CA# 1258 Case File: SP-69-11

Case File / Name: SP-69-11 / Glenwood Vintage I

Nature of Case: This request is to approve a duplex with 2 bedroom units on a 0.171 acre tract at

**SUBJECT:** SP-69-11 / Glenwood Vintage I

Proposed SP-69-11 Plan

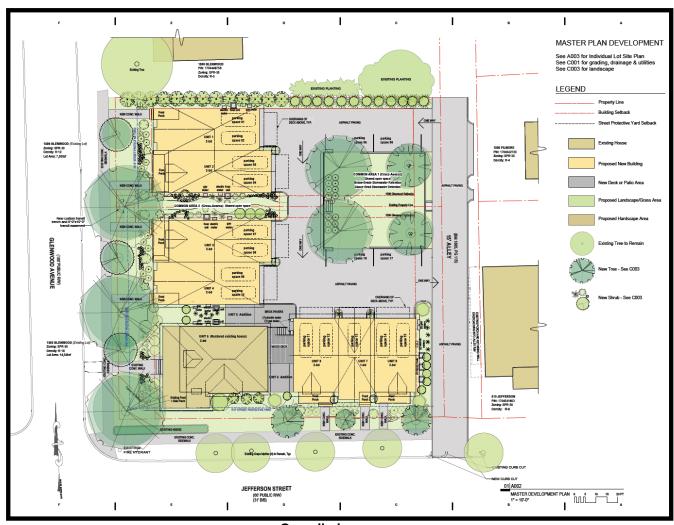
<u>Applicant is proposing</u>: A 5-ft transitional protective yard utilizing 8' tall evergreen plantings, planted 6' on center at installation (see response below for detail).

LocationYard type requiredWidth proposedNorth10' Type D5' alternate 8' tall shrubs- 6' o.c.

Given the varied architectural forms and design details found in the neighborhood, reduce the "mirror image" quality of the two new Glenwood Avenue buildings through addition of further neighborhood-compatible design features (e.g., dormers, gable vents, railing details, etc.) unique to one building or the other [commensurate with Code Sec.

Given neighborhood character, like uses, and the neighbor's expressed acceptance, the commission supports reducing the width of the required side lot-line transitional protective yard without the addition of a solid privacy fence [commensurate with Code Sec. No comment

Applicant complied with additional details as specified by Appearance Commission, see elevations.
